Technical Service Bulletin: TSB101103

Released Date: 07-Jan-2011

ISX Cylinder Block Compatibility

Cylinder Block Hardware Kit; Part Number 4955501, Location Breakdown

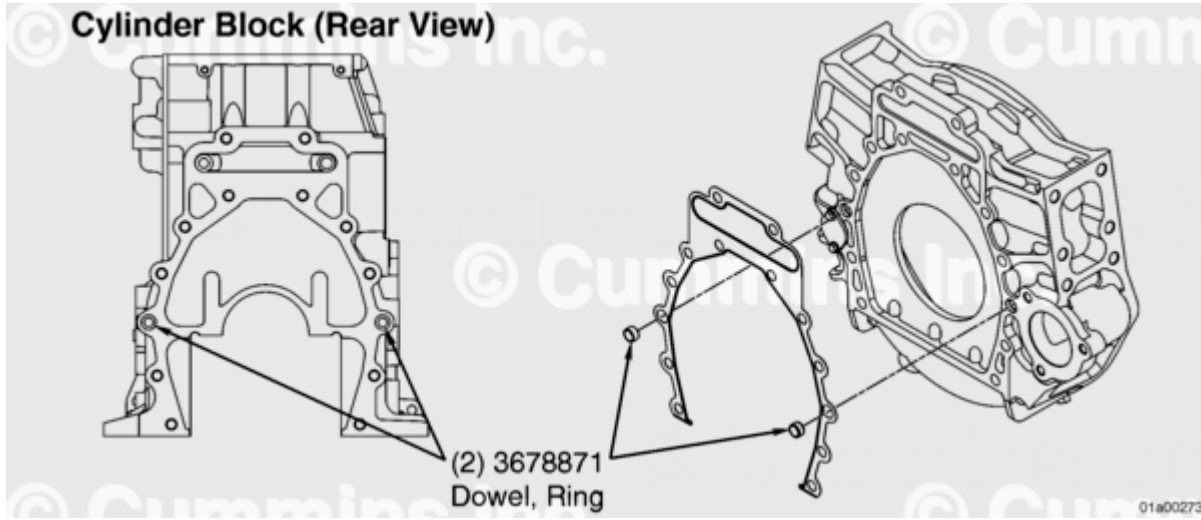
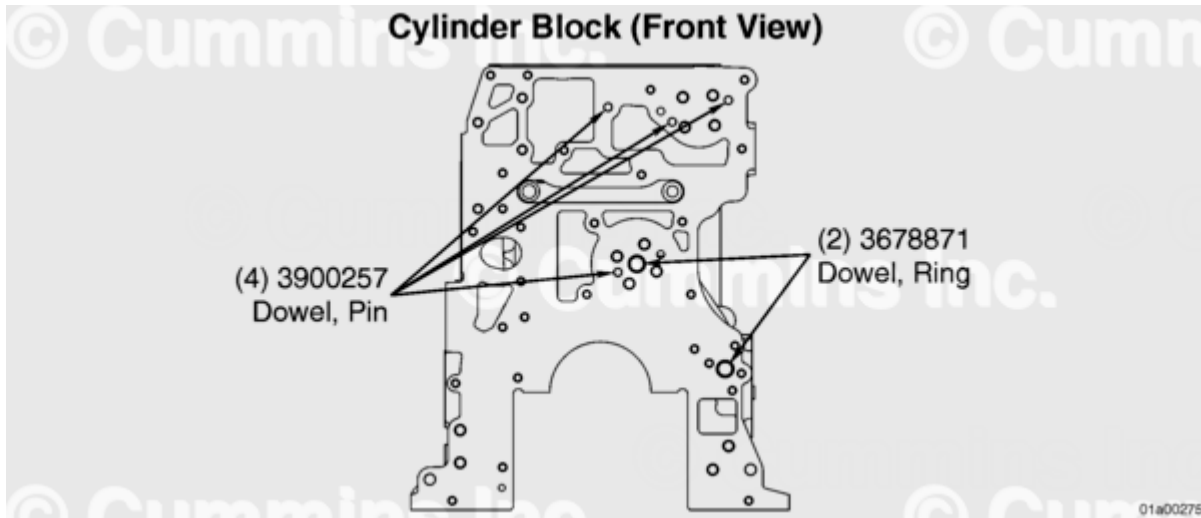
Not all of the components included in the Cylinder Block Hardware Kit, Part Number 4955501 will be needed for every ISX engine model.

Additional engine model specific parts will be needed for engine block replacement.

ESN prior to 79259454 (Built July 24, 2007):

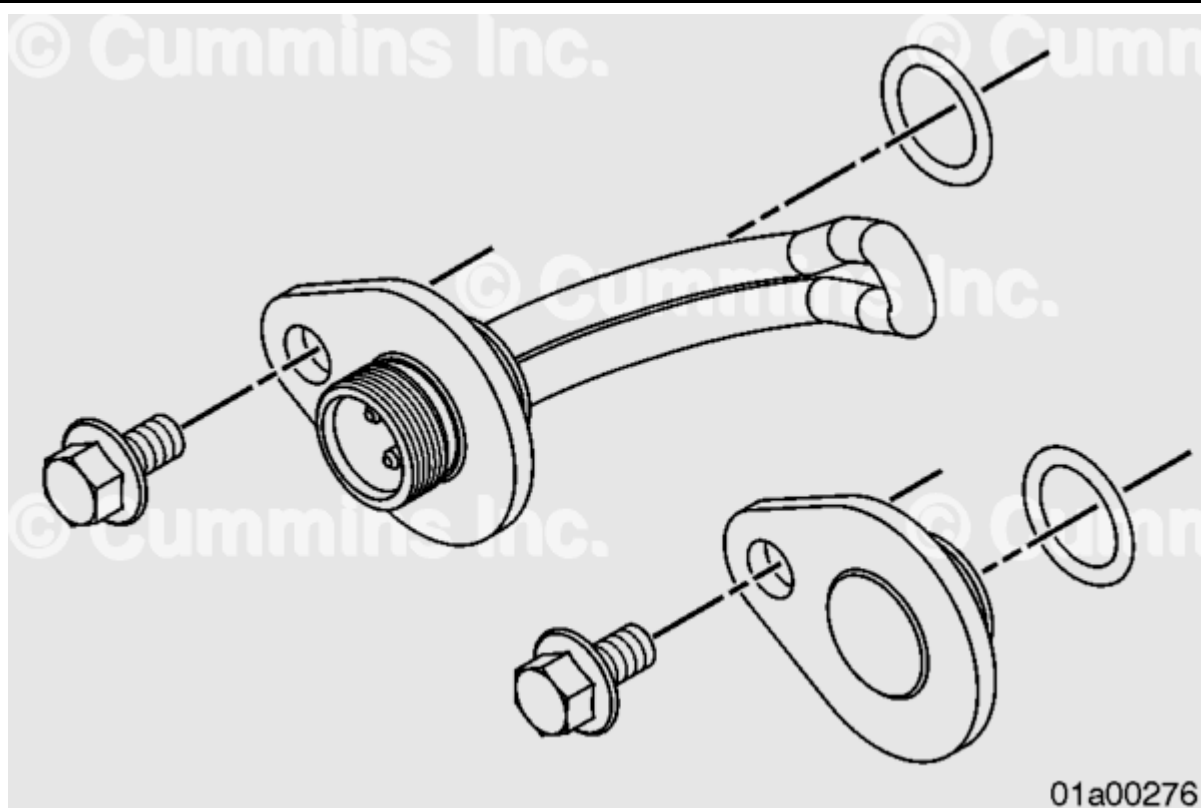
The new cylinder block features the ISX CM871 designed block heater port and requires the use of a CM871 designed block heater or a CM871 designed block heater port plug. The new cylinder block is backward compatible to cylinder blocks with an ESN prior to 79259454, by virtue of installing a new block heater or block heater port plug.

Reference TSB100758 for additional information and part numbers for the block heater and block heater port plug.

ISX CM870, CM570, Signature™ (ESN prior to 79204200, built August 31, 2006):

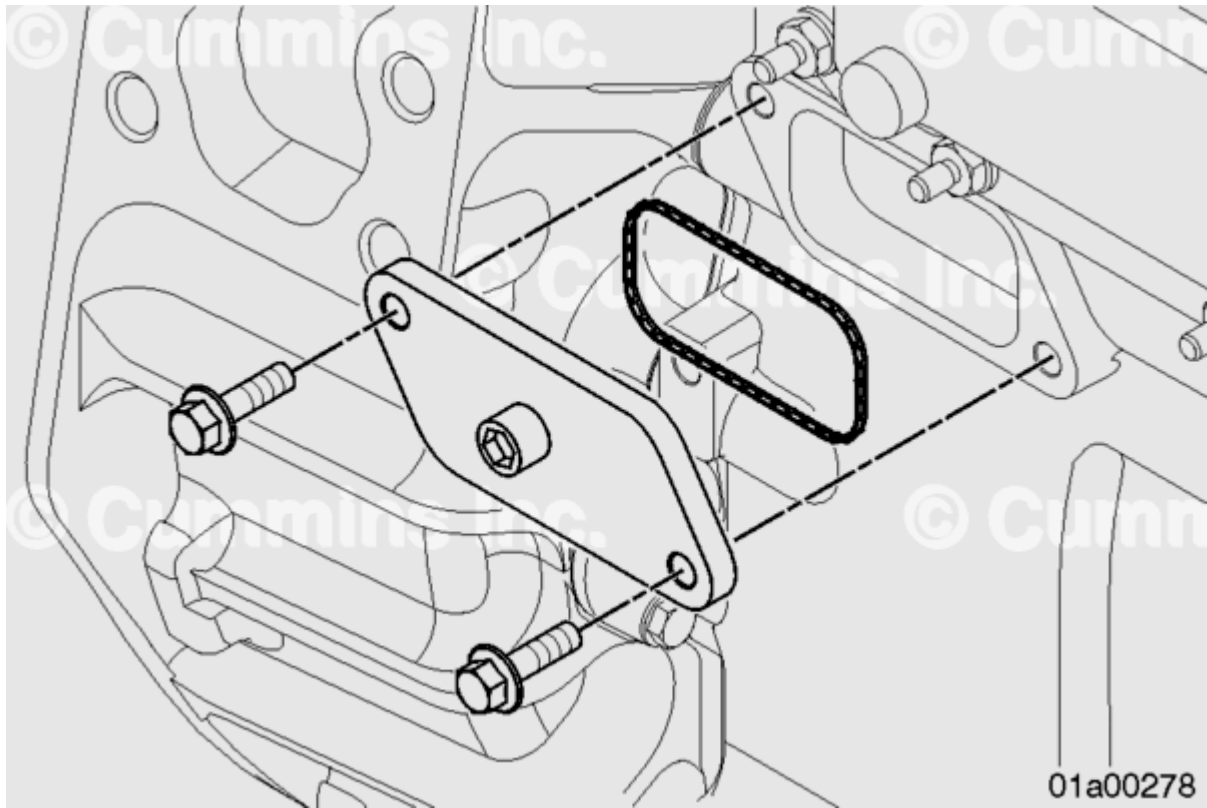
The new cylinder block features a coolant return port that was specifically designed to provide a coolant return for the ISX CM2250 and CM871 EGR coolers. The coolant port is located on the exhaust side, at the rear of the engine, just below the lubricating oil cooler. The new cylinder block is backward compatible to ISX CM870 and older cylinder blocks, by virtue of installing a coolant cover plate.

Reference TSB100526 for additional information and part numbers for the coolant cover plate.

Early Signature™ Engines

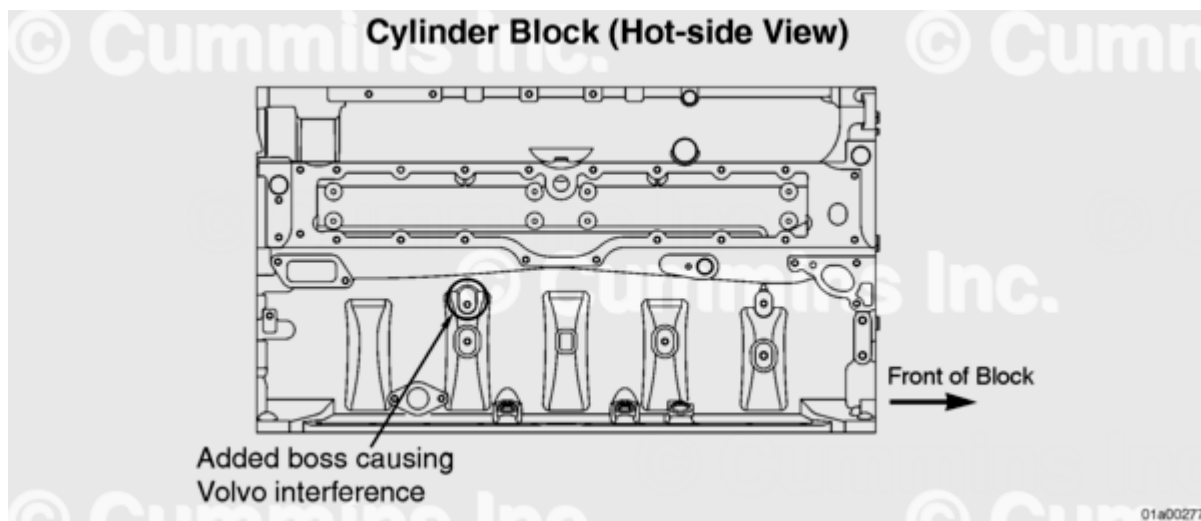
Approximately the first 950 ISX engines built, ESN 14000000 through 14000950, used a different tone wheel on the crankshaft than the crankshaft now in production, and can **not** be replaced with this service block kit.

Reference TSB100331 for additional information on replacing the blocks for these engines.
